ADDENDUM NO. 1

RFP EVMS GROSSLAB19-101

Gross Anatomy Lab Improvements at Lewis Hall

Date: May 07, 2019

HOT WATER COIL PIPING FOR AHU DETAIL
NO SCALE

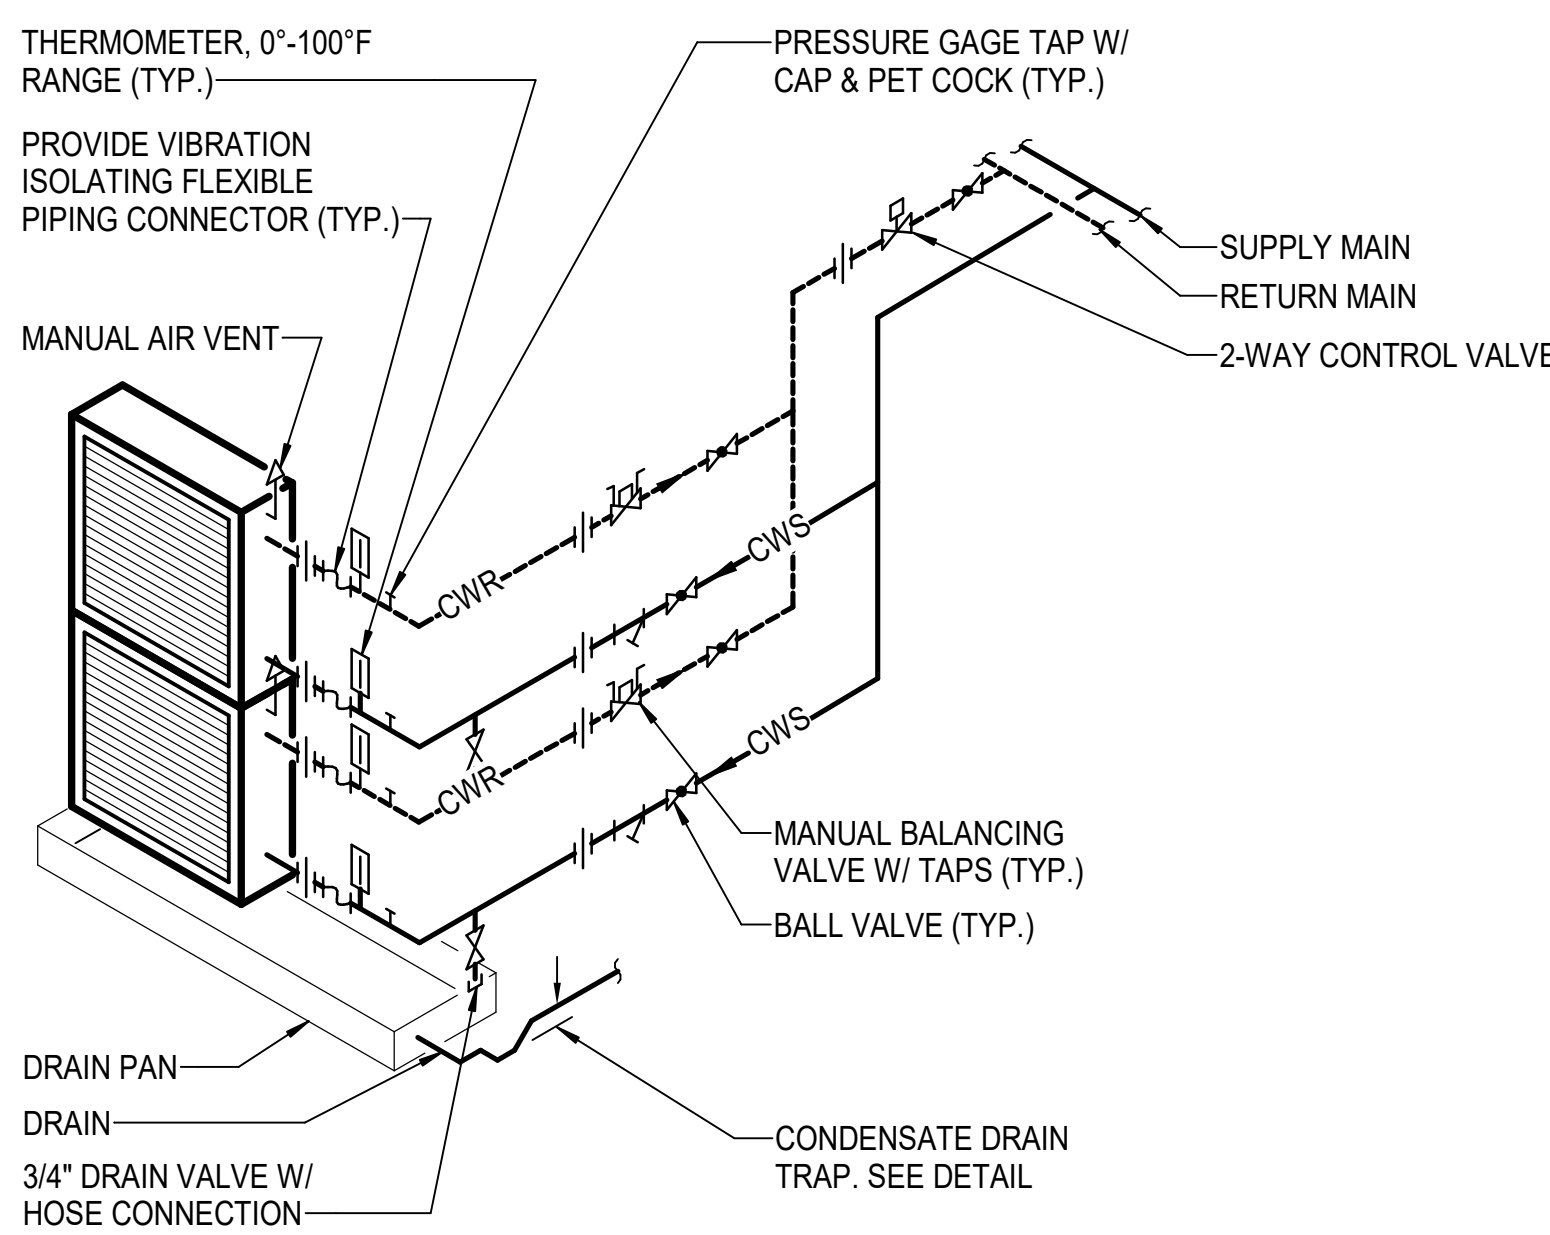
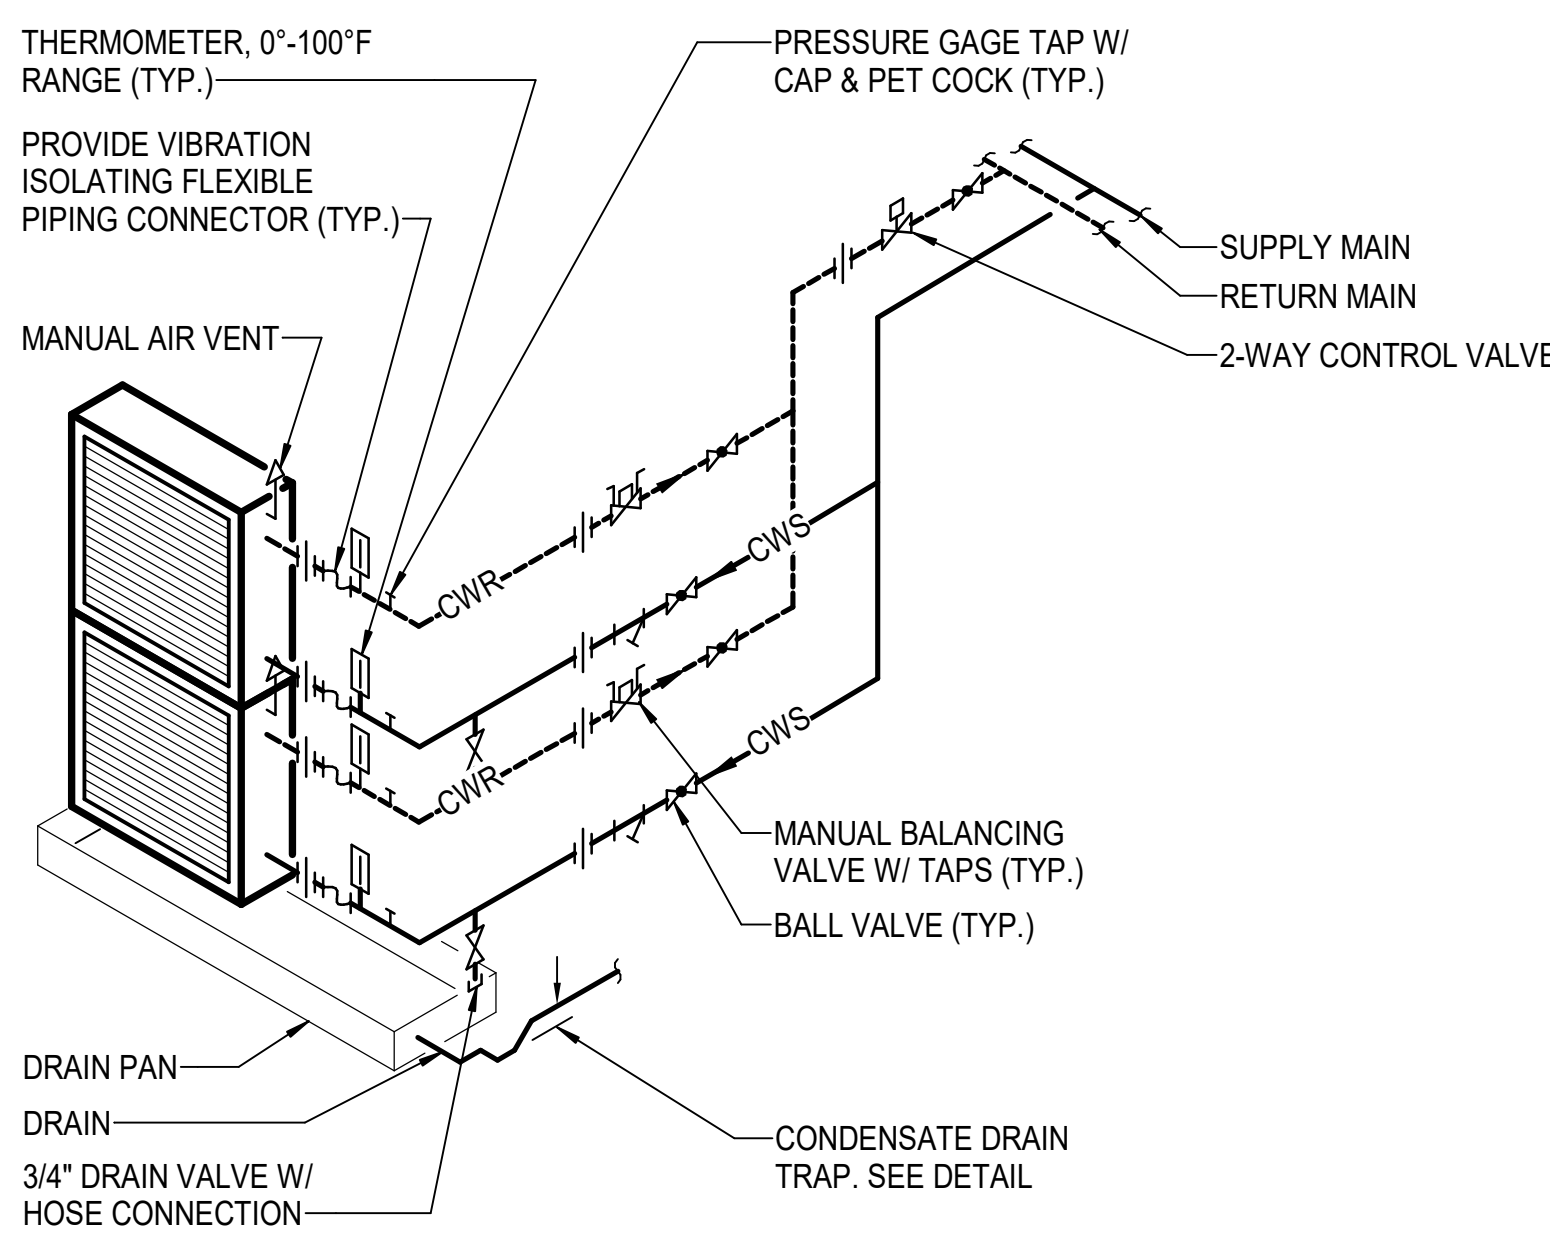
"Hot Water Coil Piping for AHU Detail" has been revised. See attached revised sheet M502.

ROOFTOP PIPING CURB SUPPORT DETAIL
NO SCALE

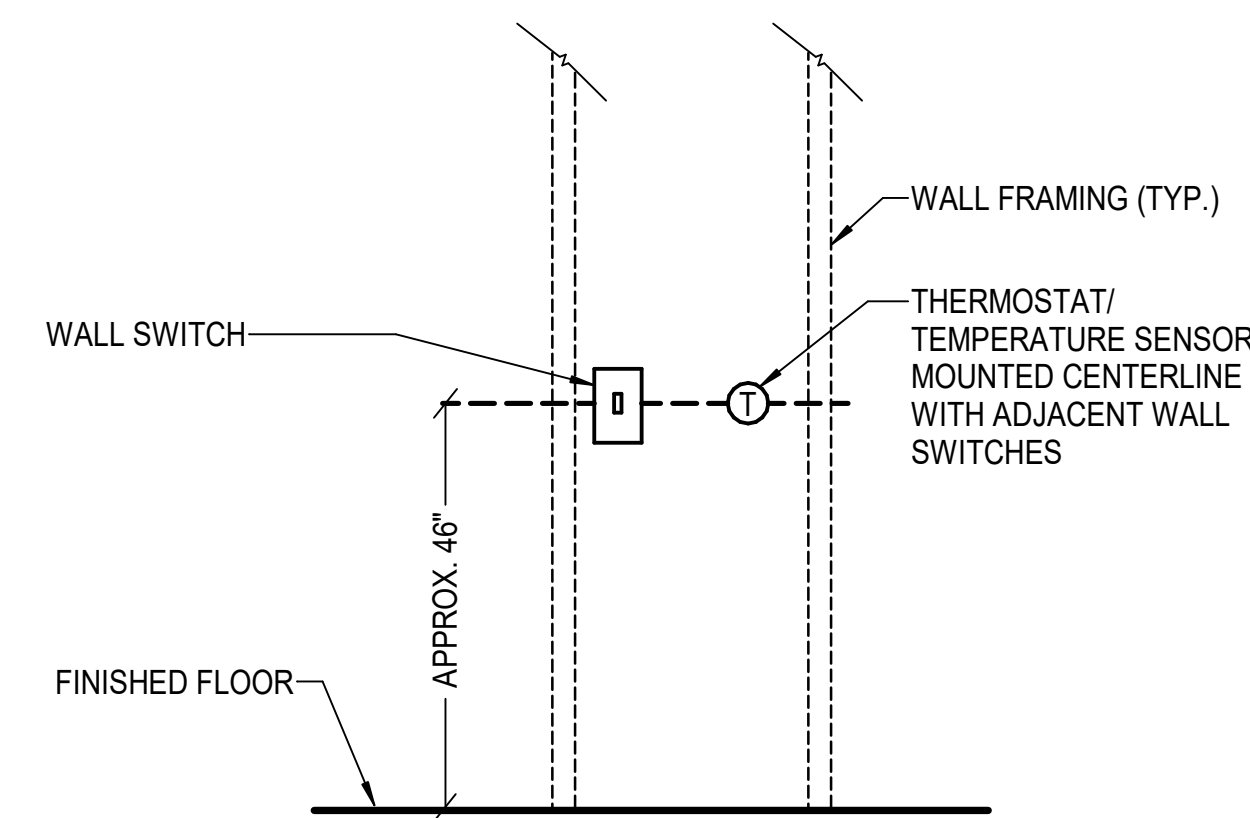
Drawing S100: The additional steel reinforcing shown on this sheet will also be required below the pipe support roof curbs. Provide similar to AHU-1 curb reinforcing. See Sheet M201 & M202 for locations. Pipe support curbs shall be centered over two joists.

Drawing M502, Rooftop Piping Curb Support Detail. Add the following note: "Provide structural steel reinforcing below each curb support in accordance with detailing for AHU-1 curb supports shown on S100. Curb supports shall be centered over two joists."

COLOR LEGEND

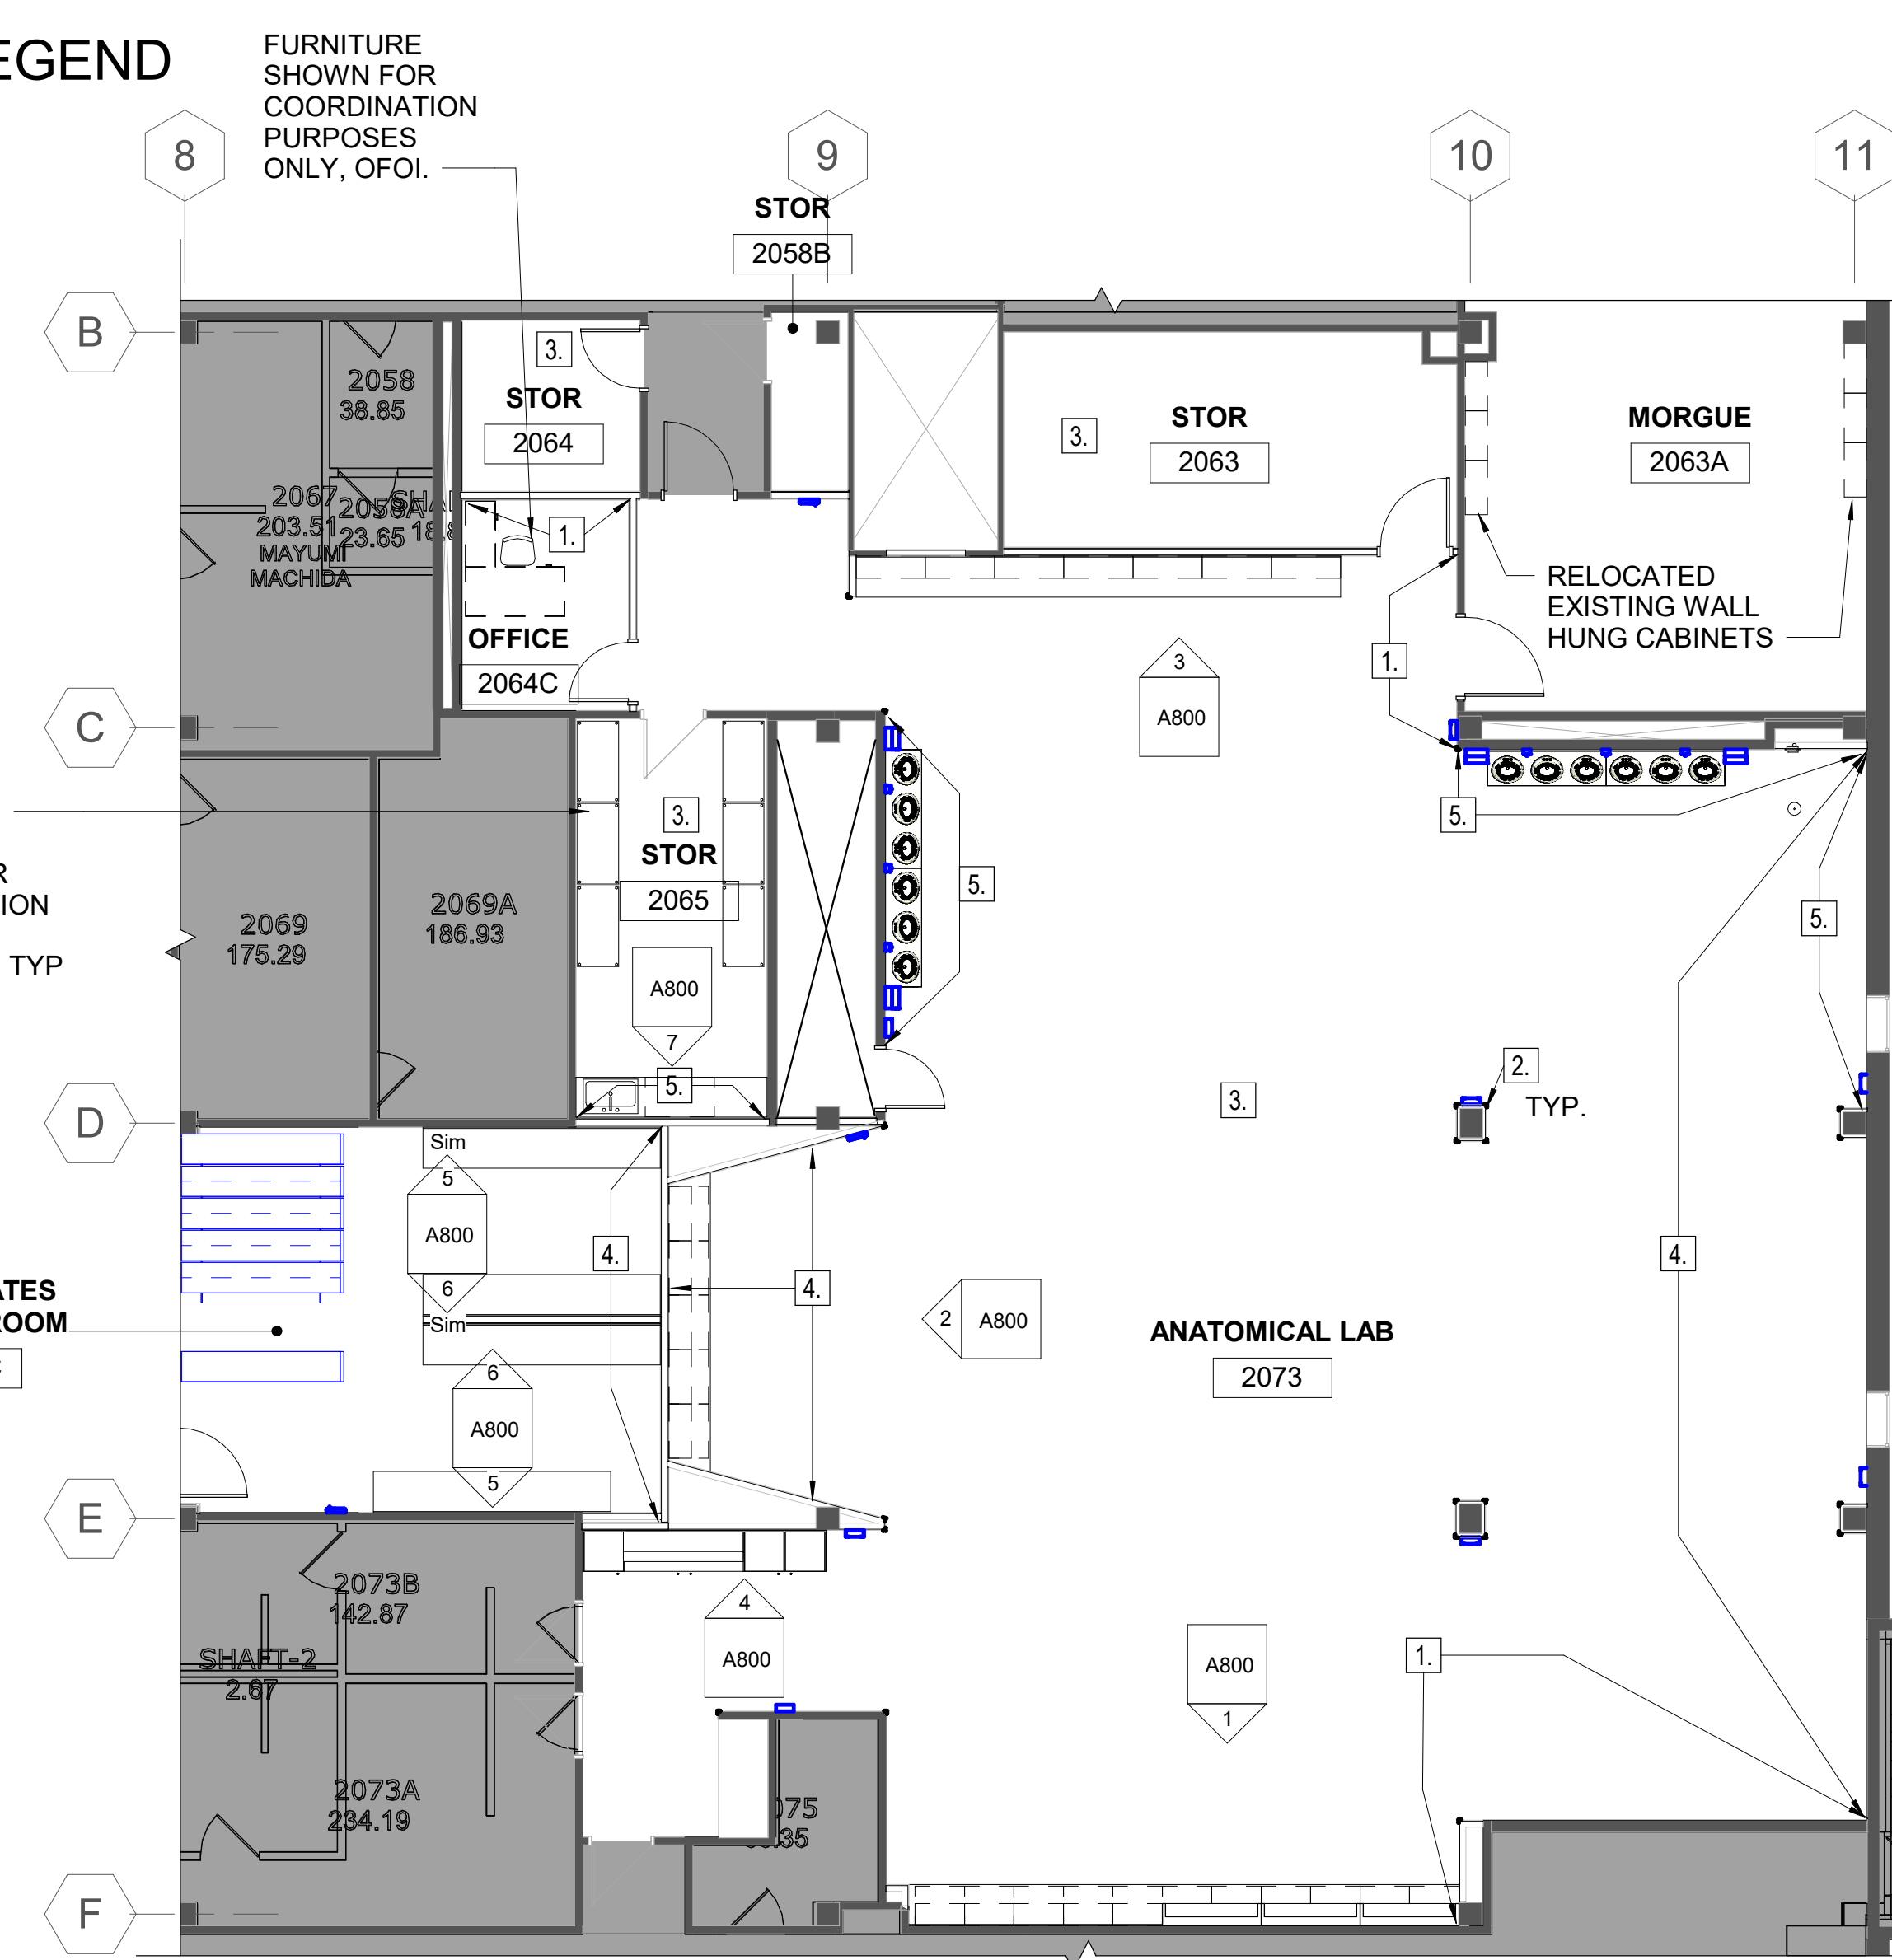
Drawing A610: The finish colors and finish schedule have been revised. See attached sheet A610 for revisions.

026	5/3/2019	A610	Please refer to the finish plan on A610. Please note that the Floor Finish plan calls out Dur-A-Flex's Hybri-Flex EC Flooring System. However the specifications calls out Dur-A-Flex's Accelera HC Flooring System. Pleas verify which is preferred.	Dur-A-Flex Accelera HC is preferred. This has been corrected on Addendum #1 Drawing Sheet A610.		
027	5/6/2019	260500	Please provide a manufacturer and type of bus duct and panel for panels HMA and LMA.	Existing bus duct is GE "Armor-Clad", existing panel HMA is Westinghouse "PRL2", and existing panel LMA is Westinghouse "PRL1."		
028	5/6/2019	283100	Please confirm the existing fire alarm system as Simplex.	The existing fire alarm system is a Simplex system.		
029	5/6/2019	E201	Sheet E201 shows location of FBO new AHU-1. Please provide the columns lines as the contractor is to provide a new feeder. Also, please verify the height of the roof.	Columns are shown on E201 and the roof where the AHU-1 is being installed is at the same elevation as the second floor finished floor.
